DESIGN FEATURES

## 5.0 DESIGN FEATURES

## DESIGN FEATURES

Figure 5.1-1  
Site and Exclusion Boundaries

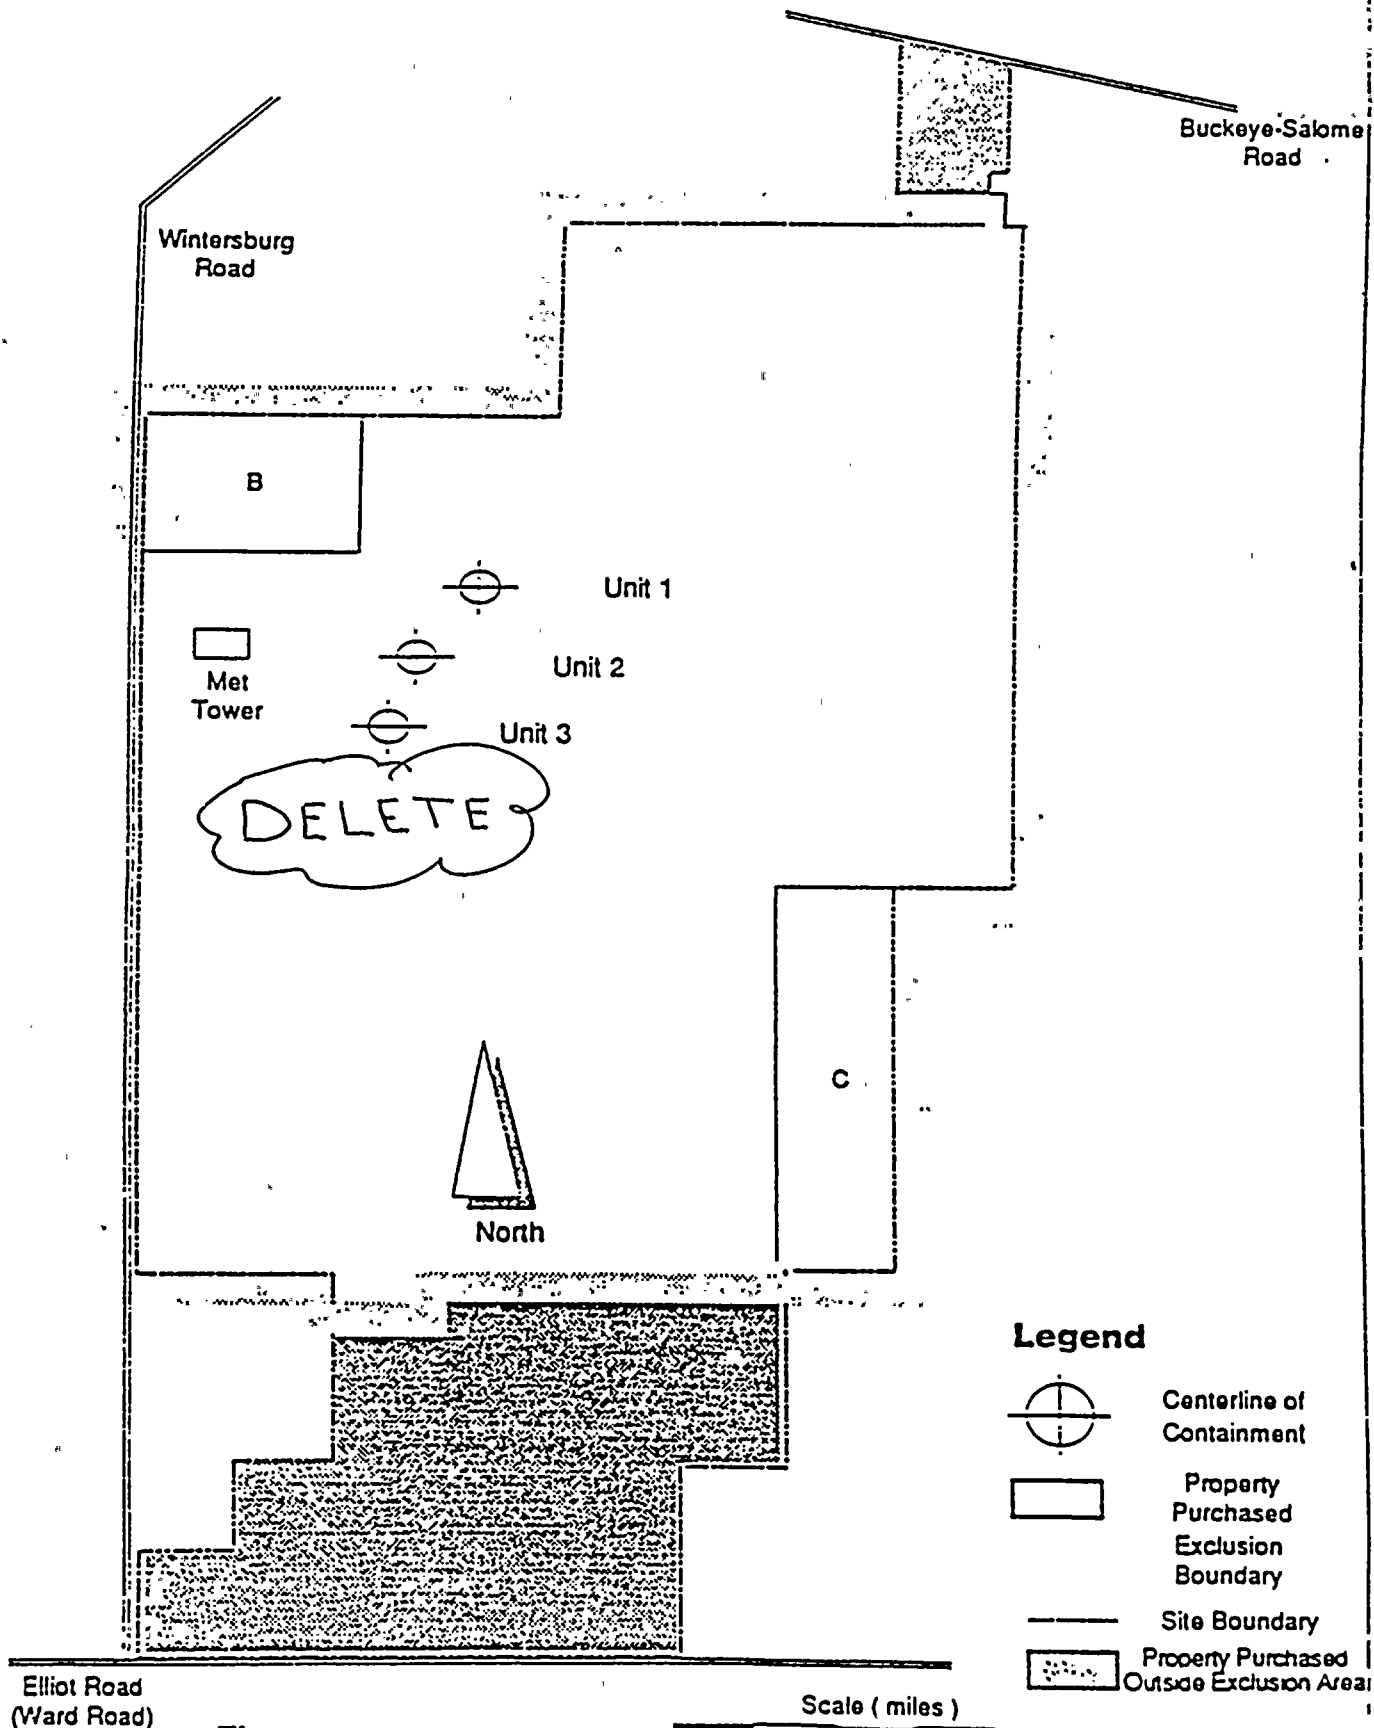
see new write up

~~5.1.1 The site and exclusion boundaries shall be as shown in Figure 5.1.1.~~

Figure 5.1-2

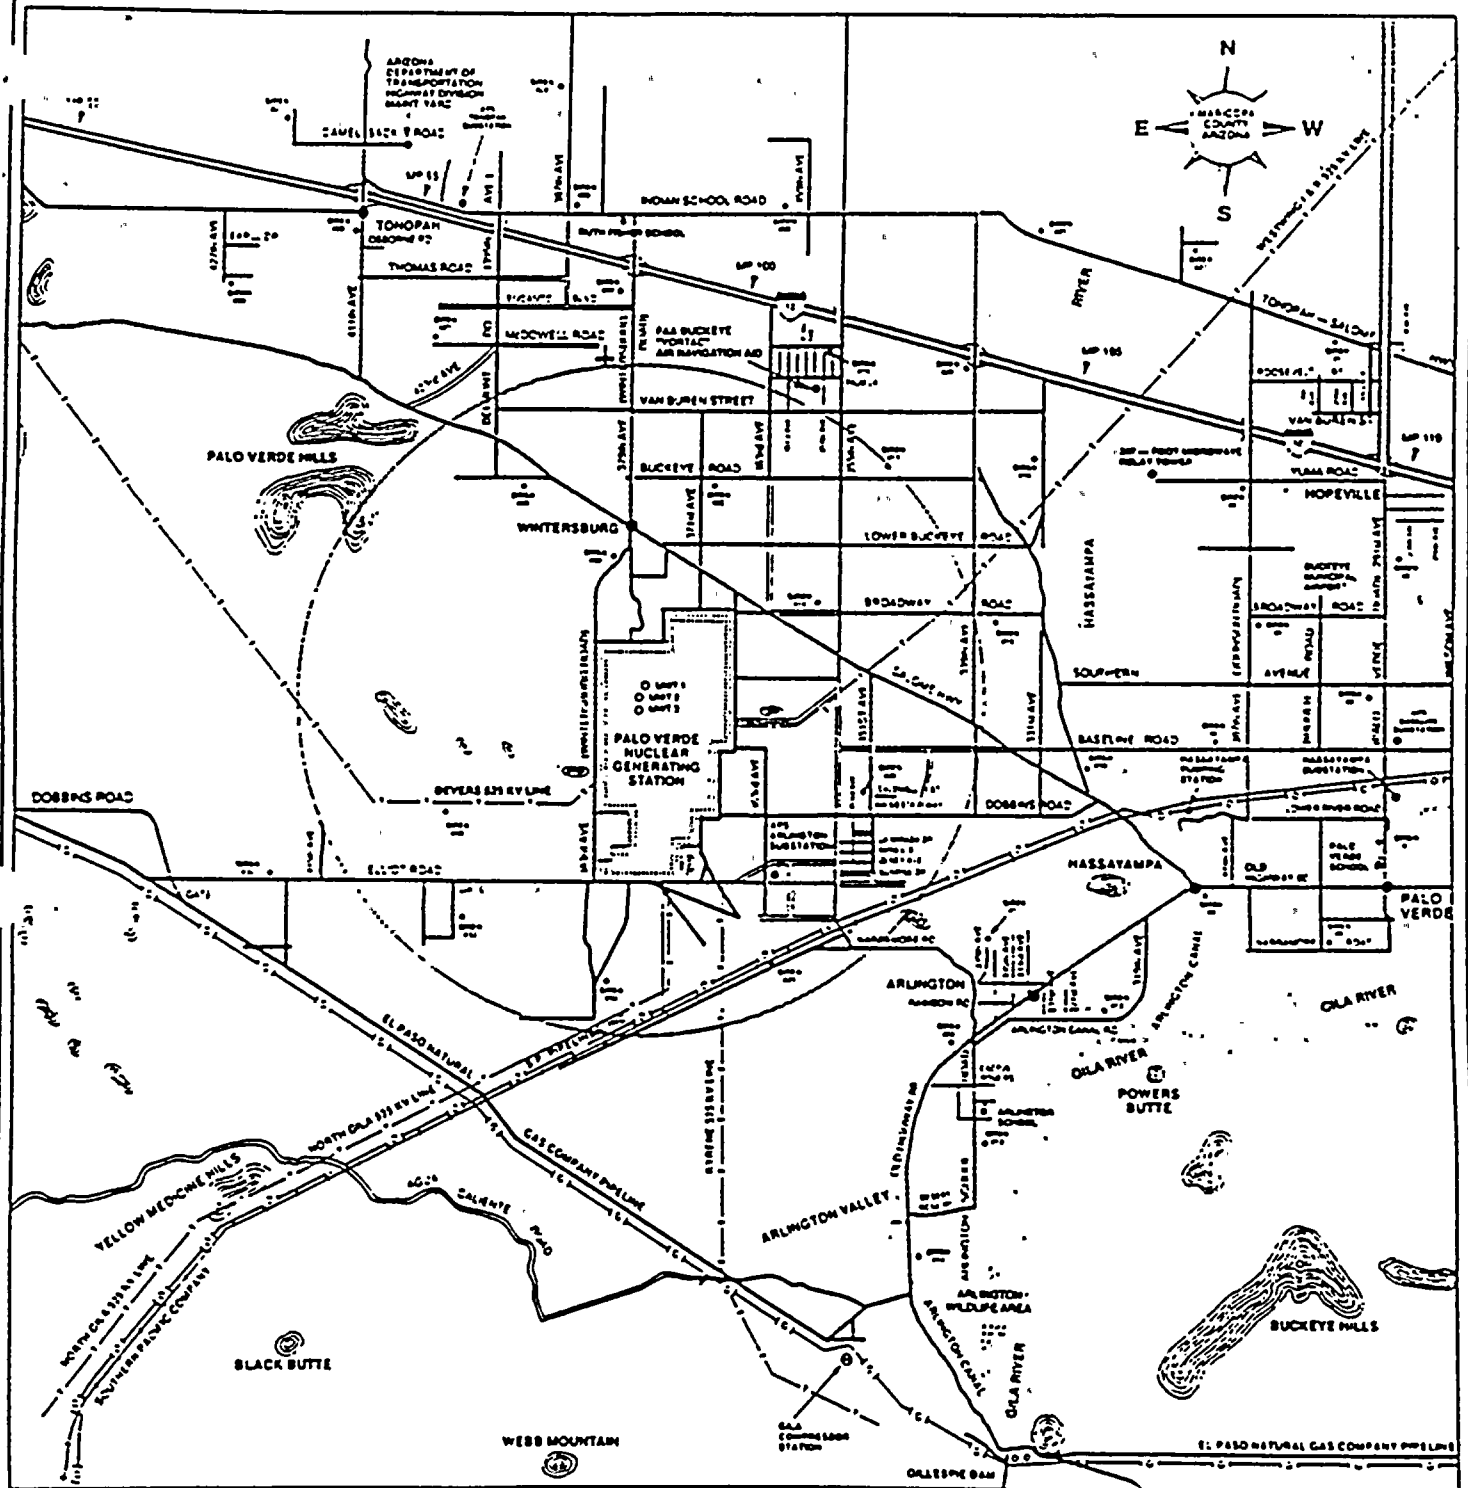
~~5.1.2 The low population zone shall be as shown in Figure 5.1.2.~~

DELETE

Fig 5.1-3

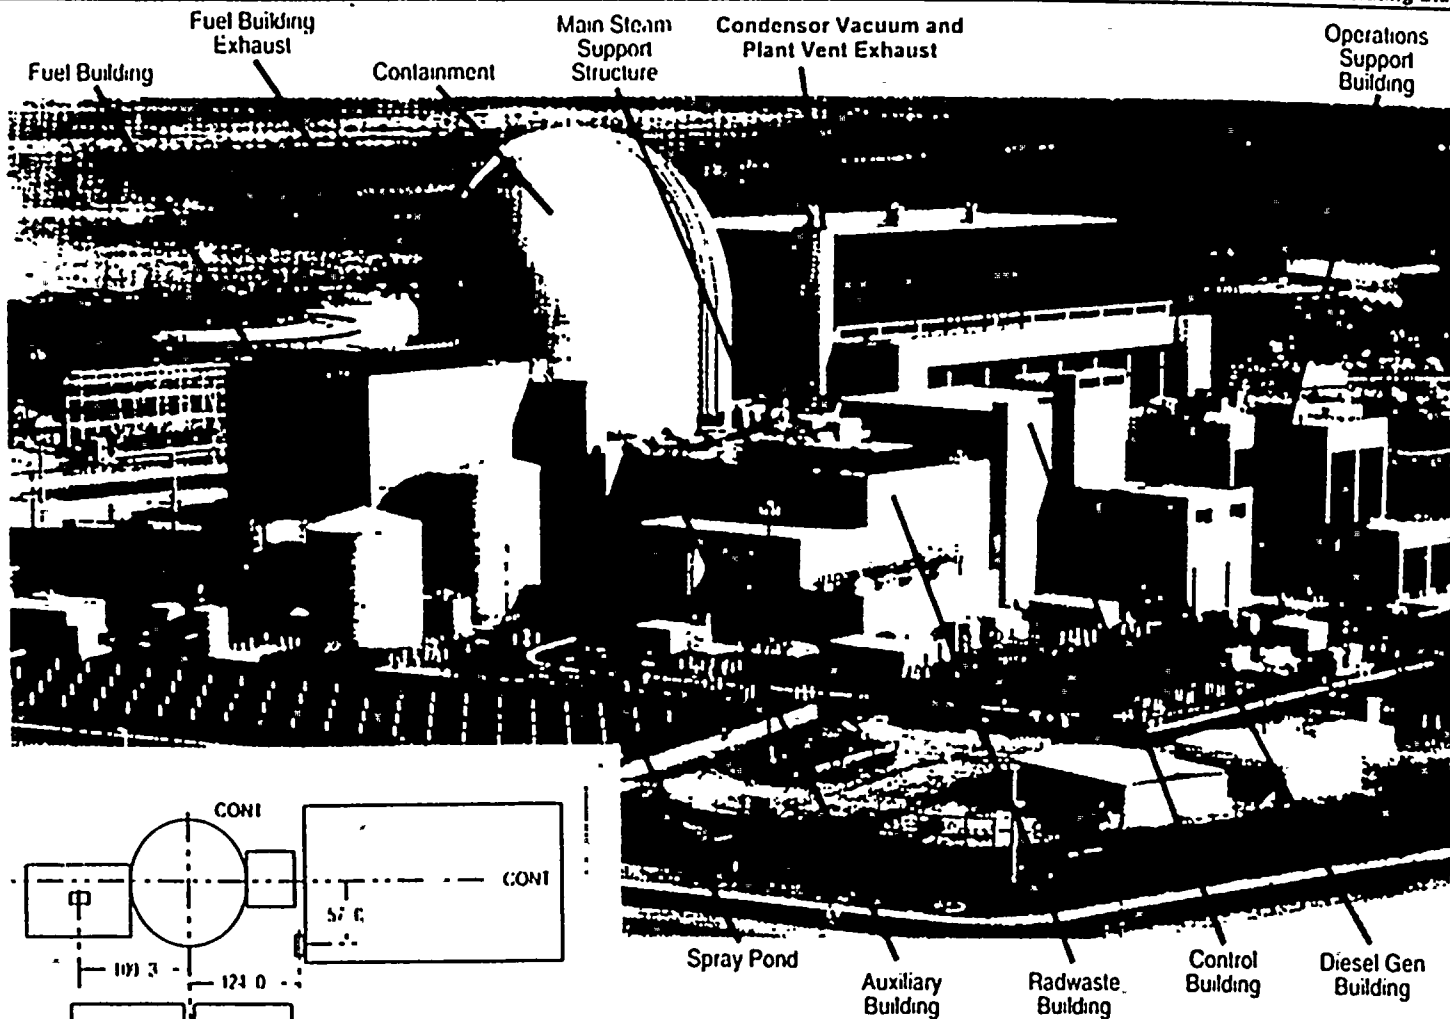
~~5.1.3 The gaseous release points shall be as shown in Figure 5.1.3.~~

**FIGURE 5.6-1**  
**ASSEMBLY BURNUP VERSUS INITIAL ENRICHMENT**

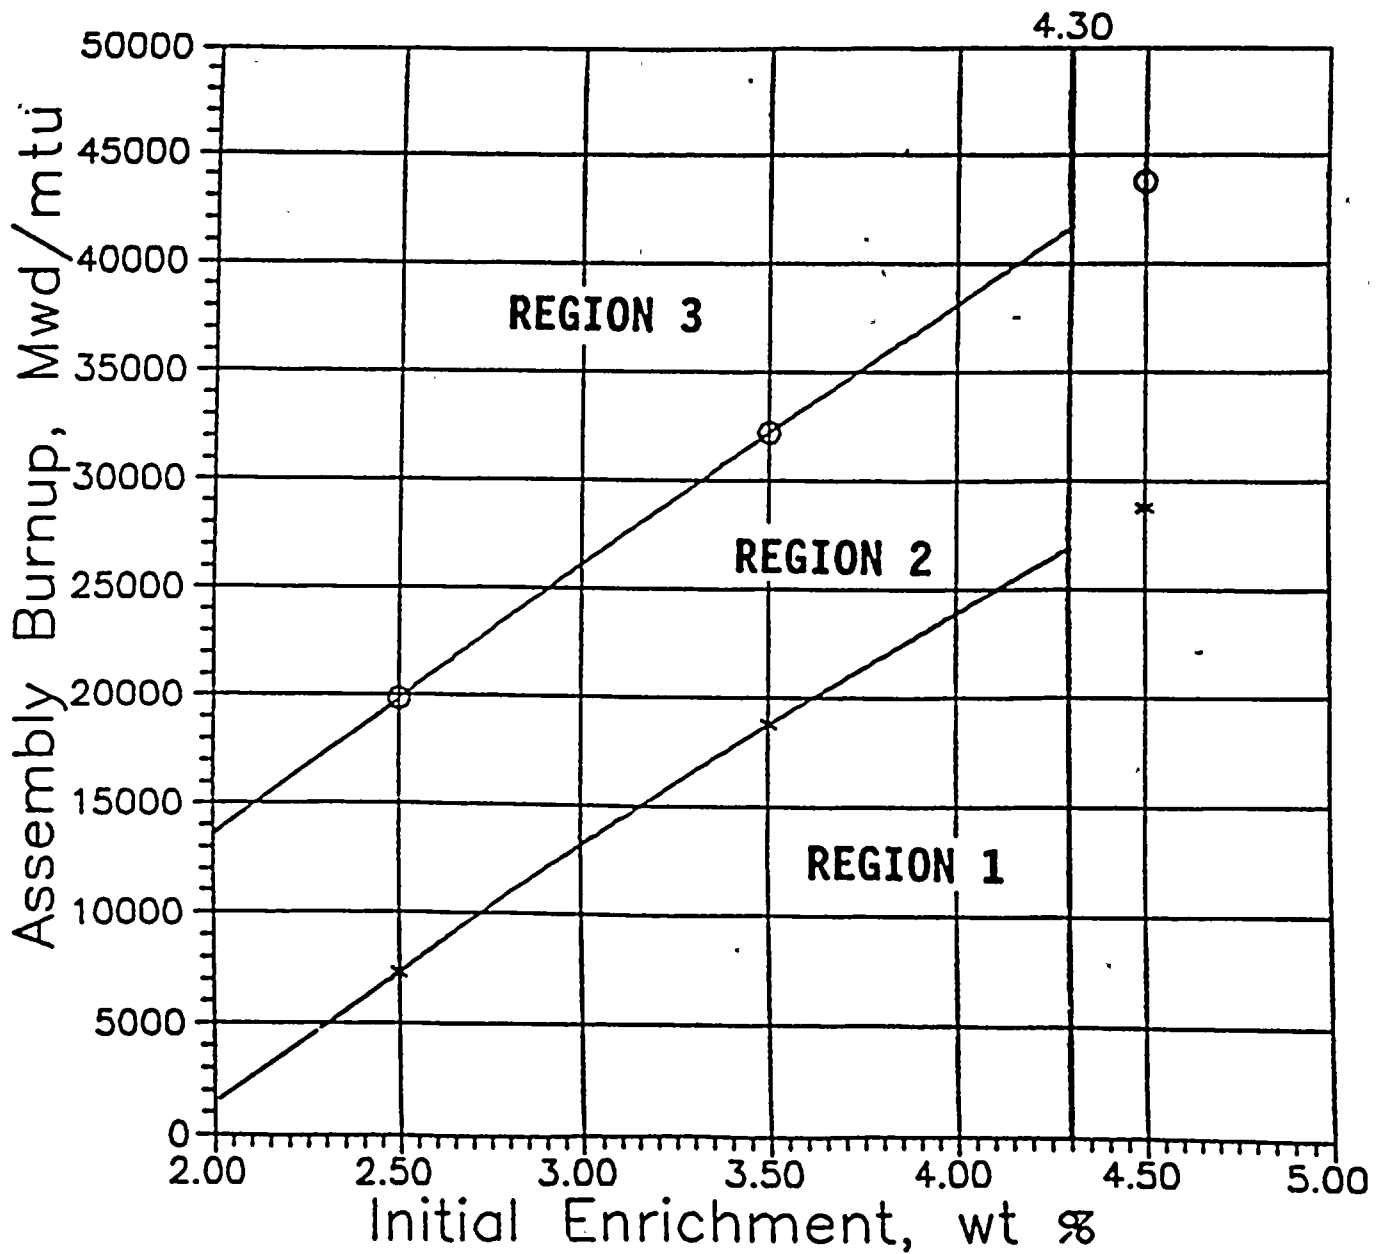
See new write up

~~5.6.1.3~~ The spent fuel storage pool is organized into three regions for spent fuel storage. Fuel shall be placed in the appropriate region based on appropriate initial enrichment and existing burnup as designated in Figure 5.6-1:

Figure 5.1-1  
Site and Exclusion Boundaries

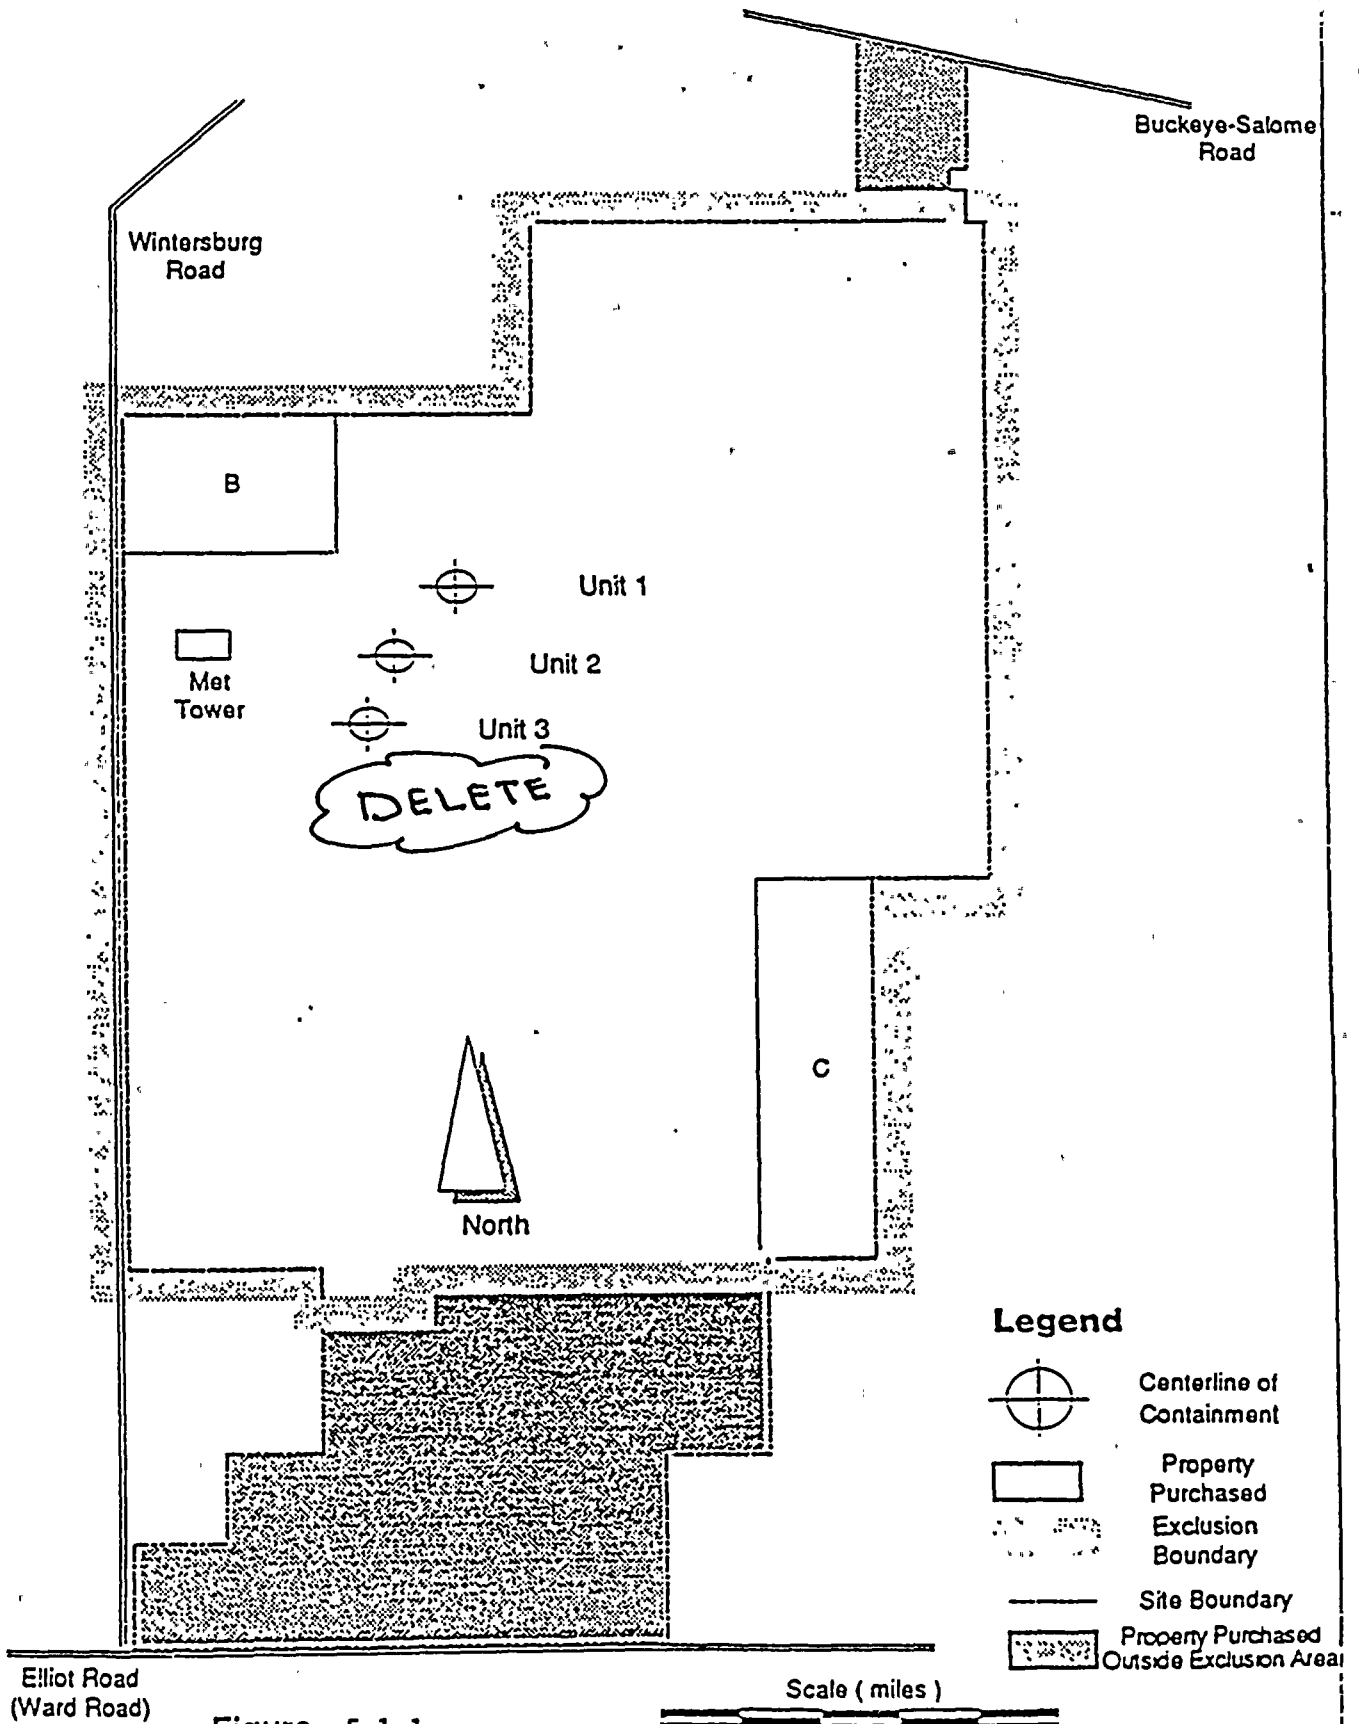
~~5.1.1 The site and exclusion boundaries shall be as shown in Figure 5.1-1.~~

DELETED
